Title: **CR's to TS 34.121 v3.10.0 for approval**

This document contains 23 CRs to TS 34.121 v3.10.0. These CRs have been agreed by T1 and are put forward to TSG T for approval.

3GPP TSG-T1 Meeting #17
Luton, UK, 4th- 8th November, 2002

Tdoc ⌘T1-020631

Figure F.6.2.9

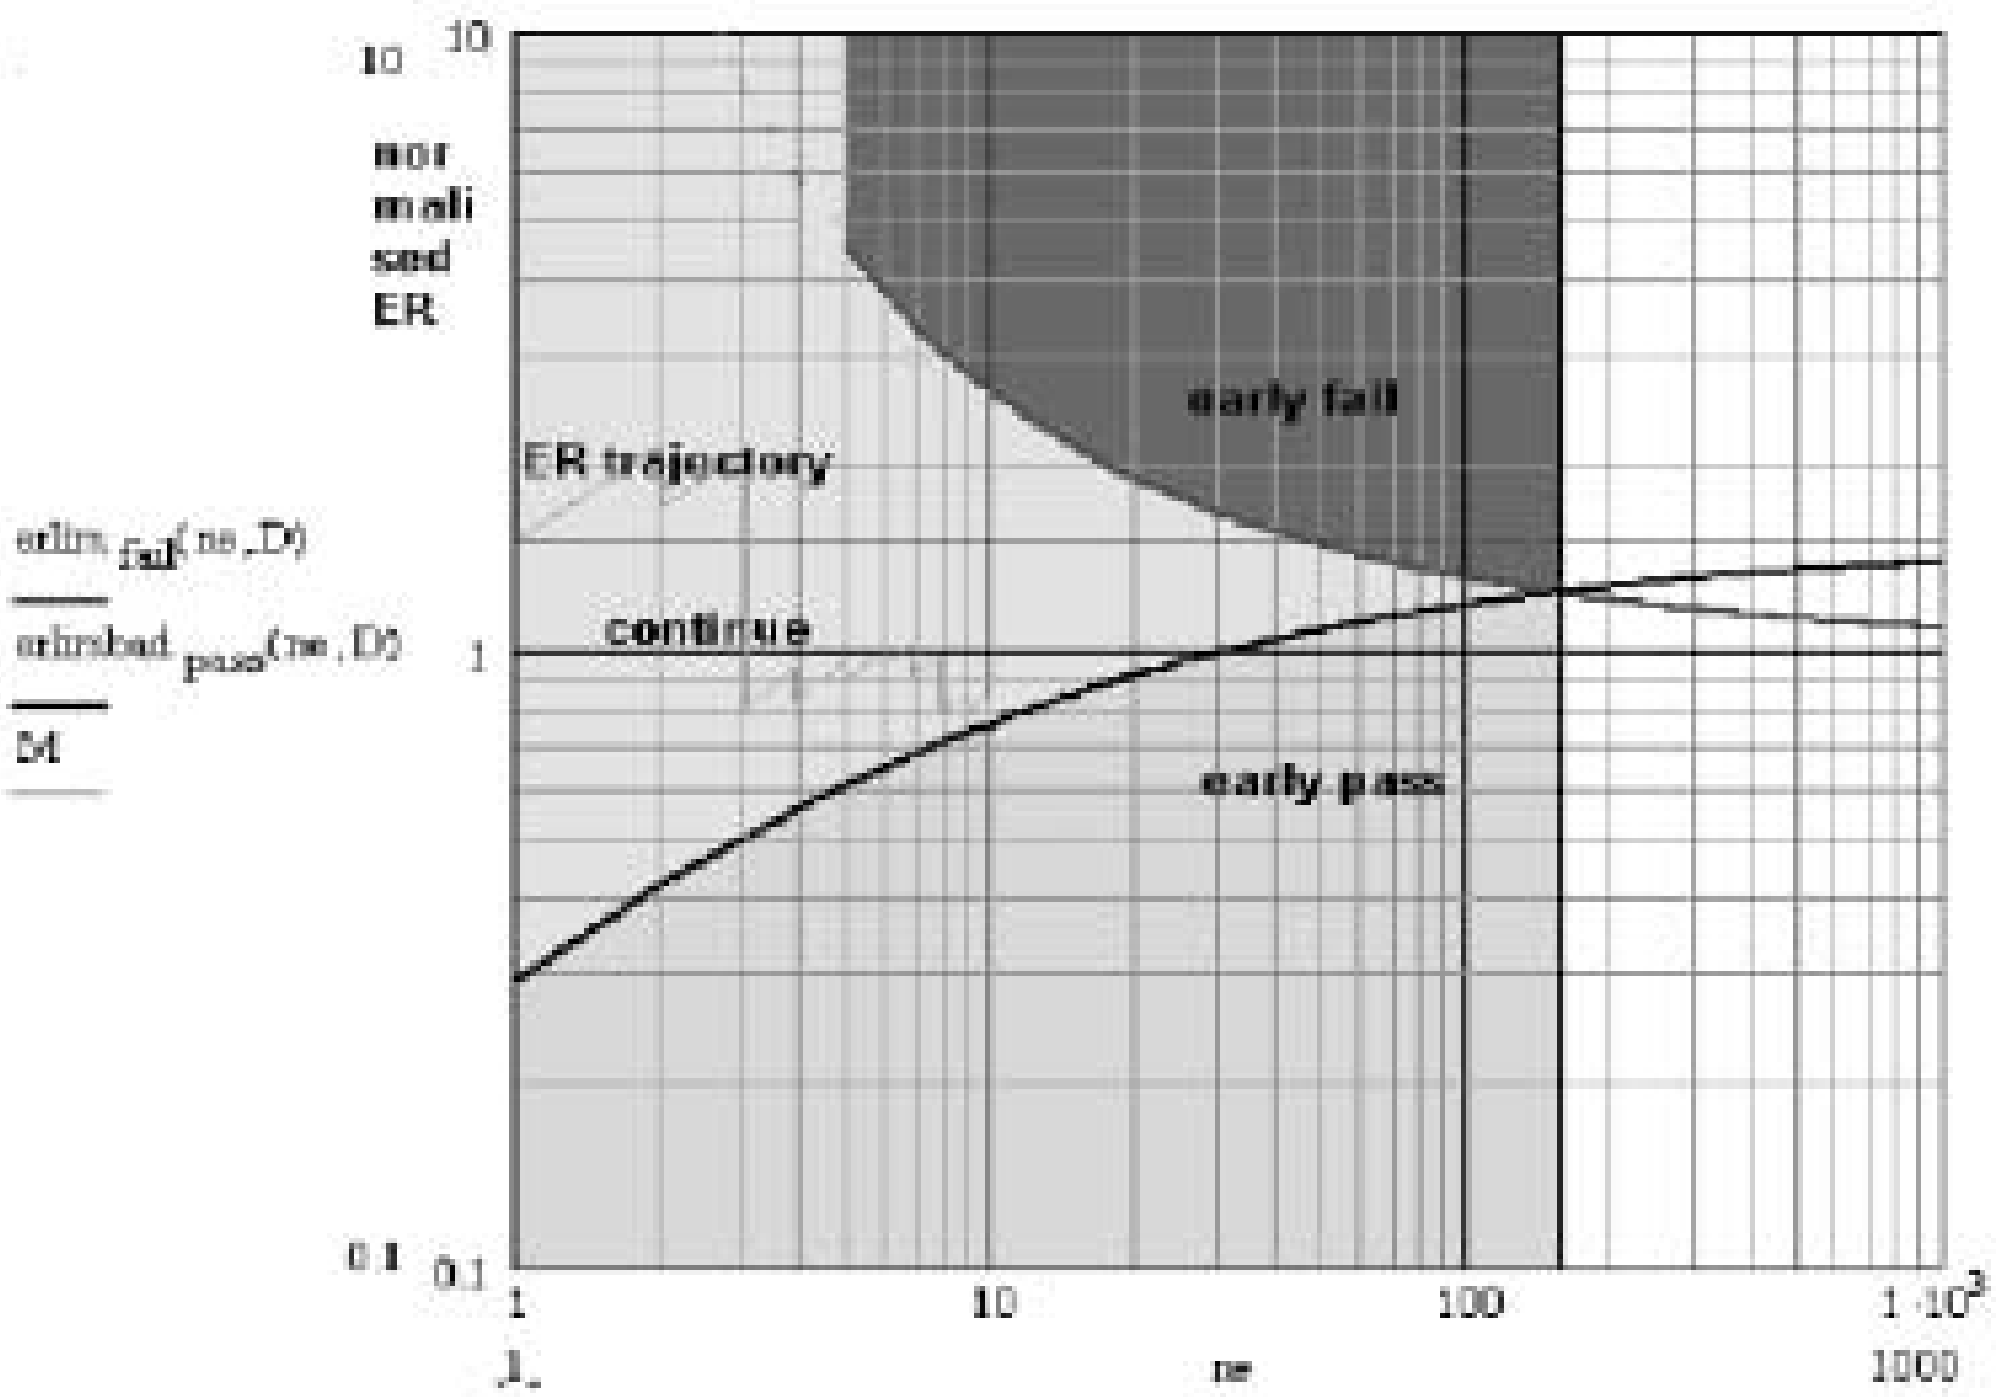
See figure F.6.2.9:
The early fail limit represents formula (1) in F.6.2.5 The range of validity is [ne≥ 5] to [ne = 154]
The early pass limit represents the formula (2) in F.6.2.5 The range of validity is ne=1 to [ne =154]. See note 1. The intersection co-ordinates of both curves are : target number of bad delays ne = [154] and test limit TL = [1.236].

Figure F.6.1.10: Dual limit BLER

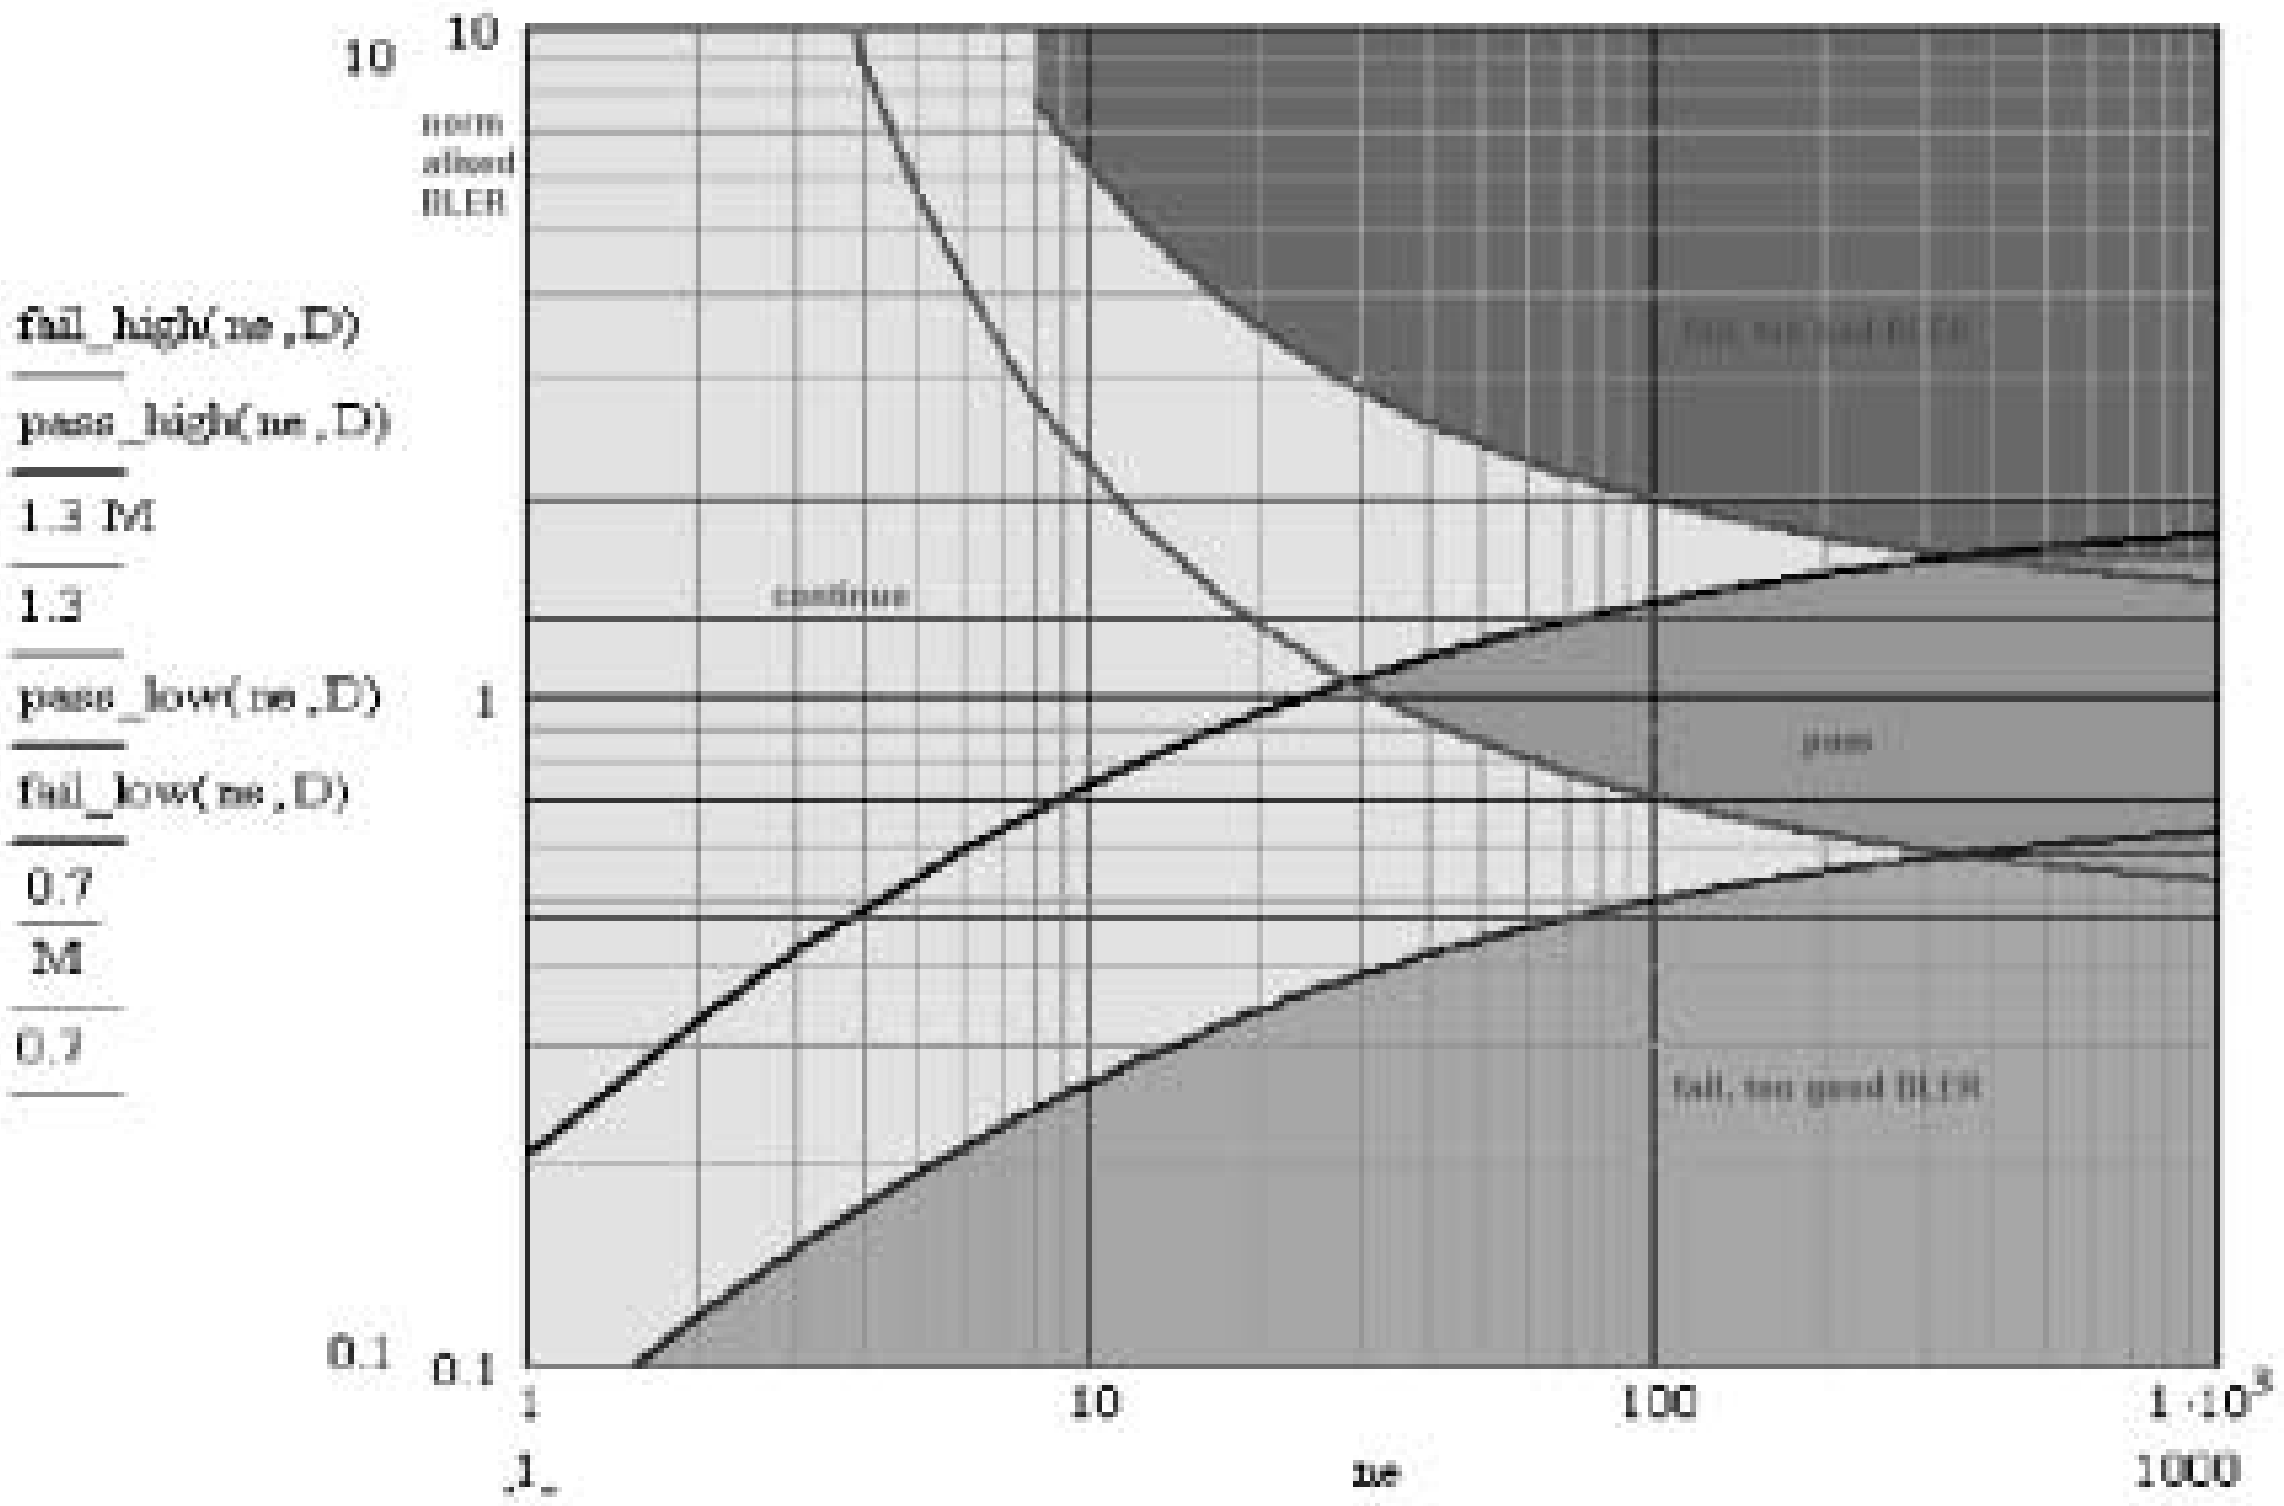
Parameters for single limit	Parameters for dual limits
Specified BER BLER	Specified BLER * 1.3 (upper test requirement) Specified BLER * 0.7 (lower test requirement)
Bad DUT BER BLER	Bad DUT BLER *1.3 Bad DUT BLER *0.7
Test limit	Upper Test limit Lower Test limit
Early fail and Early pass	Fail_high Pass_high Pass_low Fail_low

Figure 5.4.4.1: Test case for out-of-synch handling in the UE.

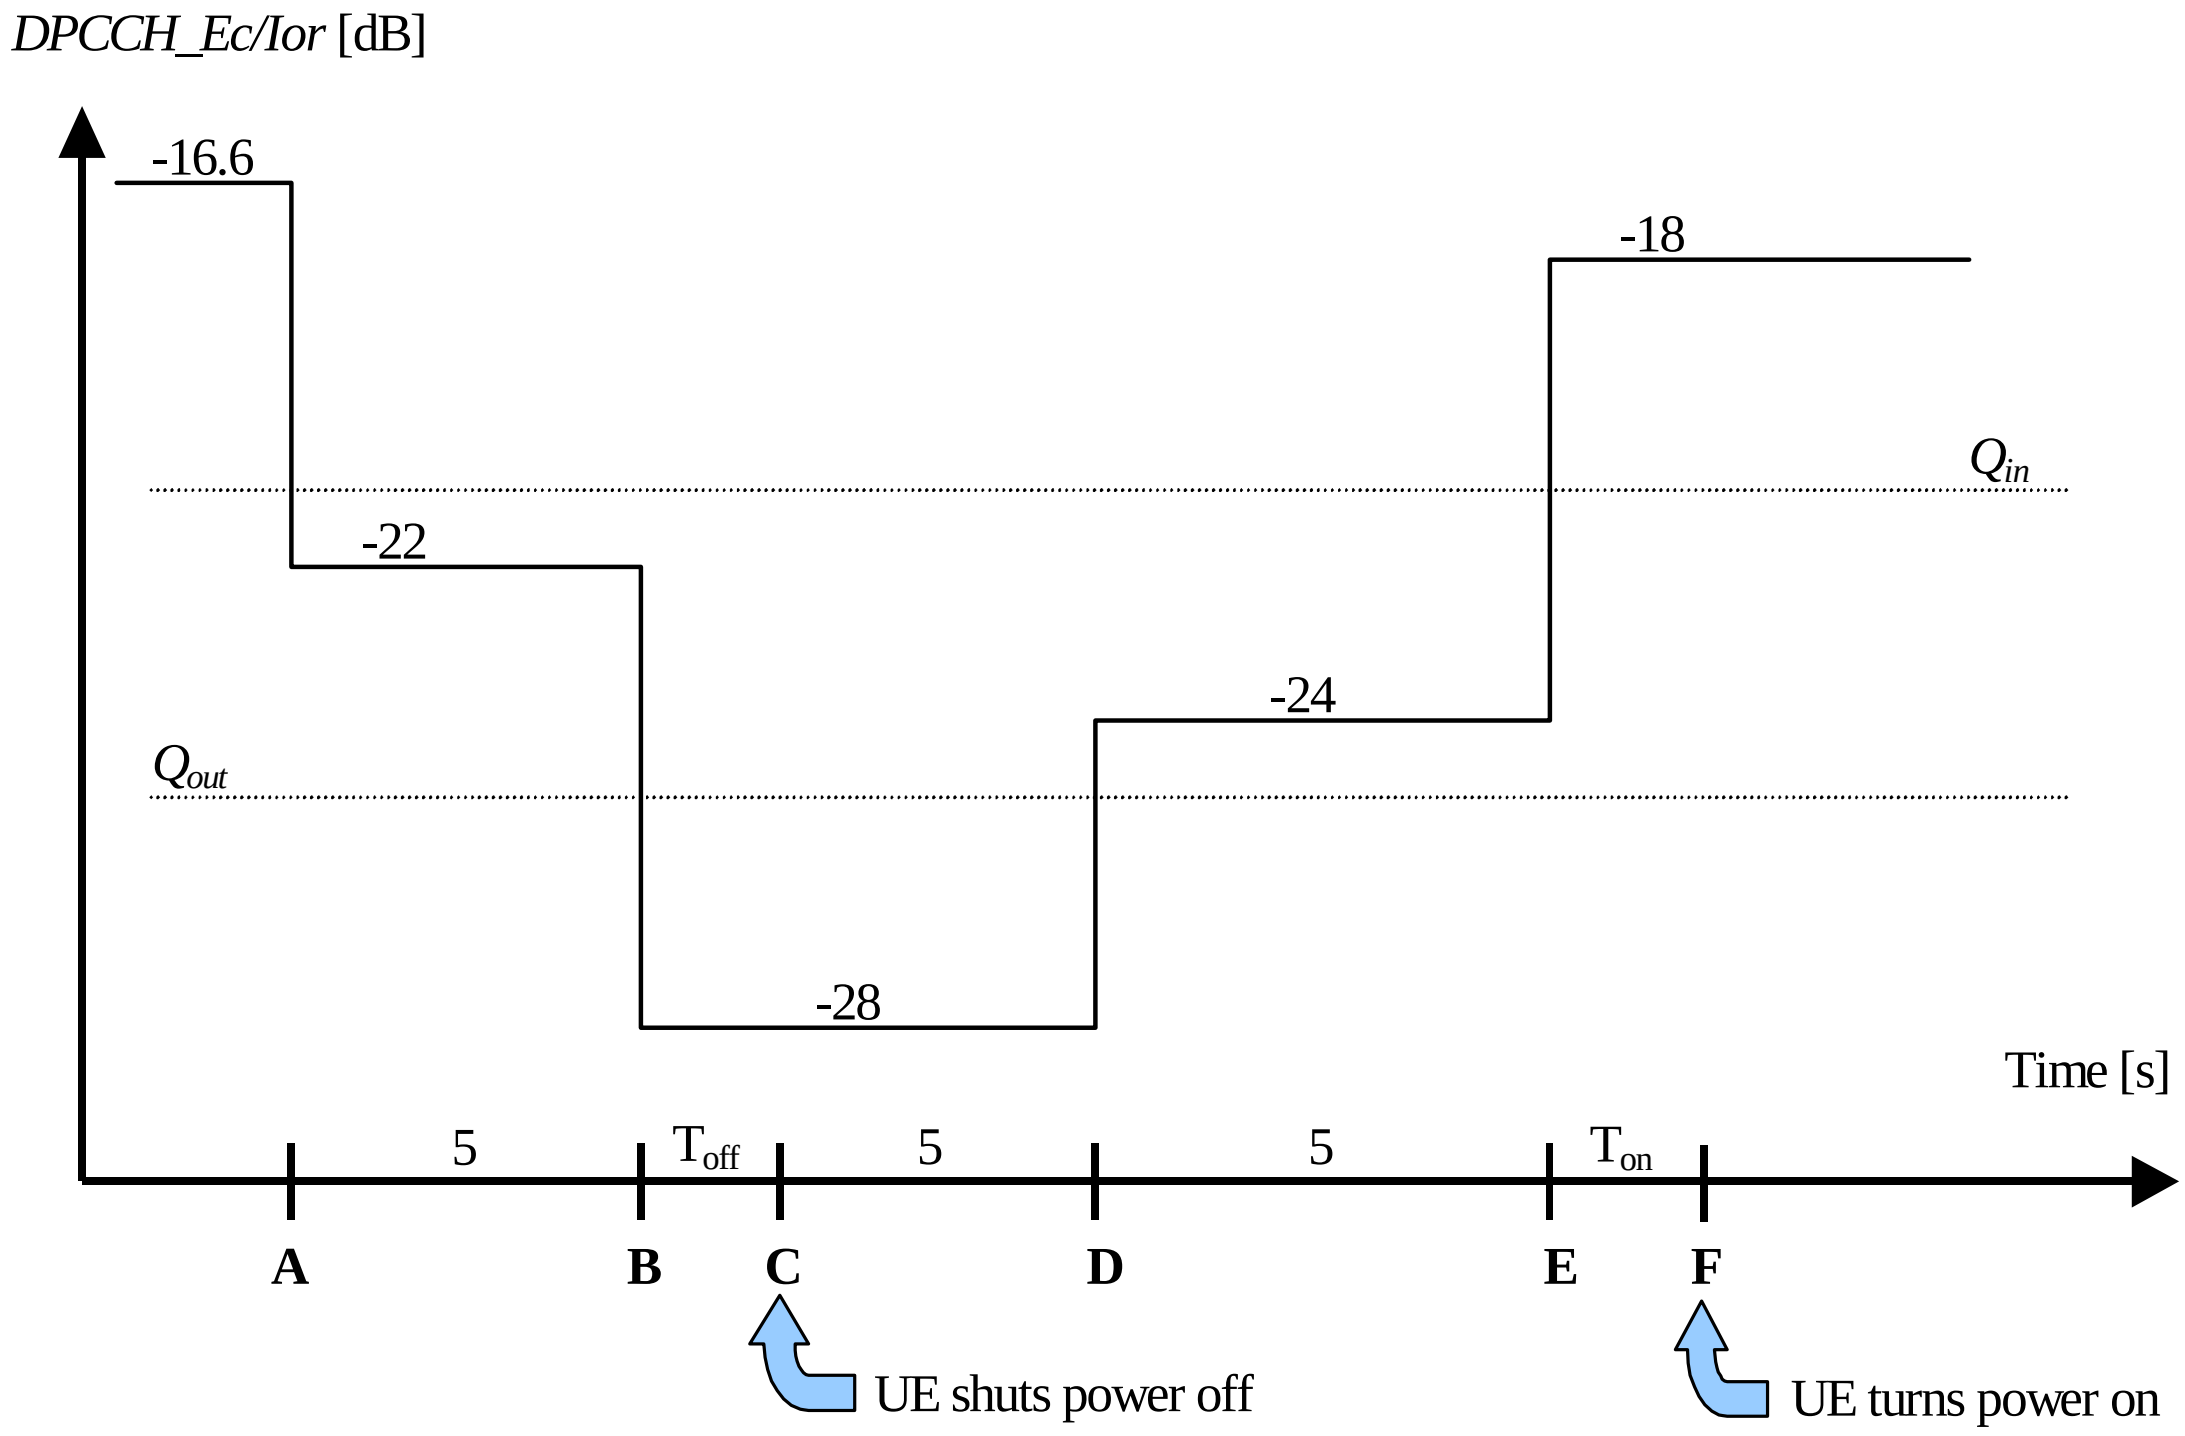
Clause from figure 5.4.4.1	DPCCH_Ec/Ior	Unit
Before A	-16,6	dB
A to B	-21,6	dB
B to D	-28,4	dB
D to E	-24,4	dB
After E	-17,6	dB
